Hale Products, Inc. Service Bulletins

Bulletin#: SB-122 **Revision#:** A **Date:** 23SEP2013

80FCK Engine-Driven Pump Gearbox – Vertical Gearbox Orientation

Problem Statement:

Figure 1 - Oil Fill Level Assembly - Factory Install Check (brass color shown for clarity)

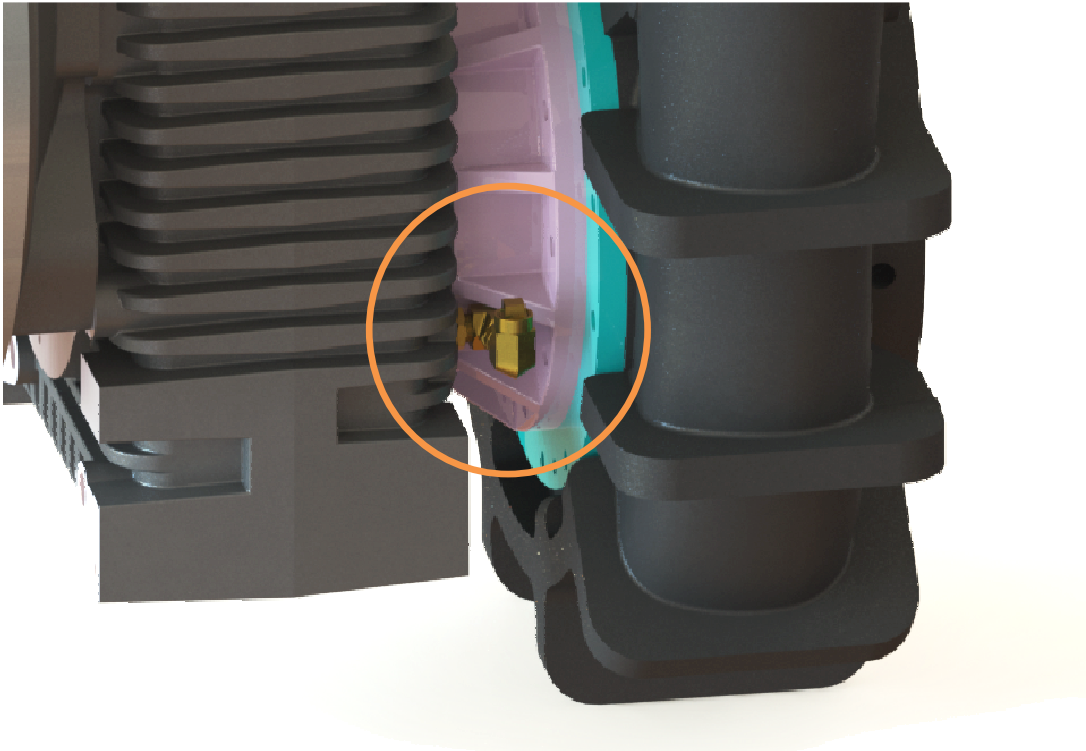
- 1) Factory Assembly Check
 - a. If your 80FCK gearbox has the pipe assembly shown in Figure 1 below, you have the correct, factory installed gearbox oil level assembly. This assembly will be painted the same color as your pump.

Figure 2 - Oil Fill Level Assembly - Retrofit Kit Install Check

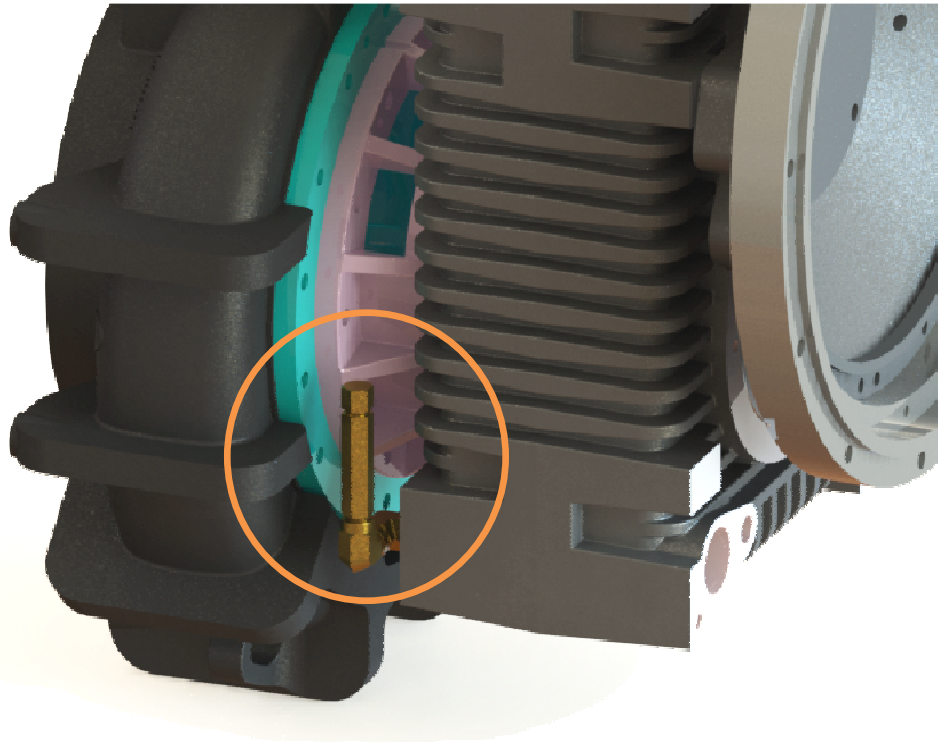
- a. If your 80FCK gearbox has the pipe assembly shown in Figure 2 below, you already have the retrofit gearbox oil level assembly installed. This assembly will have brass components and typically not painted to match your pump.

Figure 3 – Part Number 582-00025 - Retrofit Kit Assembly

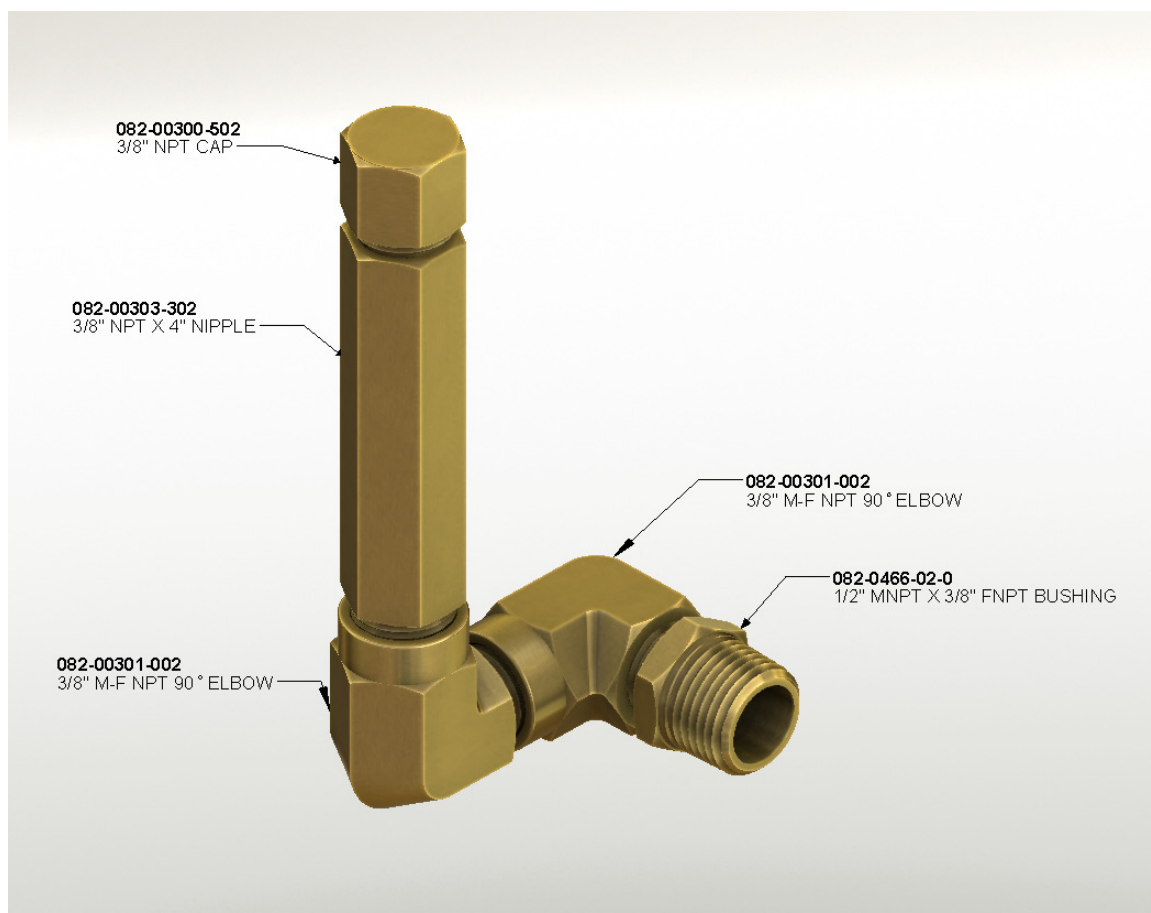
80FCK pump gearboxes in the vertical (engine shaft above pump shaft) have been shipped without the proper gearbox oil fill level pipe assembly. Without this pipe assembly, customers will not be able to accurately check the oil level inside the gearbox. If not enough oil is added after the recommended annual gearbox oil change, the gearbox could reach temperatures high enough to damage internal components.

As shown in Figures 3 and 4 below, assemble and install the retrofit gearbox oil level assembly on the bottom, right side of the pump gearbox, when looking at the suction inlet of the pump. Use the Loctite 806 threadlocker included with the kit as needed on all fittings, except the cap. The 80FCK pump uses Hale's BK gearbox assembly. The brass elbow and nipple act like an oil level tube. When filled to the top of the nipple, it offers the correct quantity of oil required for reliable gearbox operation.

To properly fill the BK gearbox, remove the cap from the oil level assembly. Remove the vent from the vent tube in the top of the gearbox. Oil should be added through the gearbox vent tube until oil spills out the top of the 4" nipple. The cap should then be reinstalled on the nipple and tightened to prevent oil leaks. Re-install the vent into the vent tube. **Oil should NOT be added through the oil level assembly** – air pockets can get trapped in the pipe assembly, creating a false reading of the oil level. If the gearbox does not contain the proper amount of oil, serious damage and failure can occur.
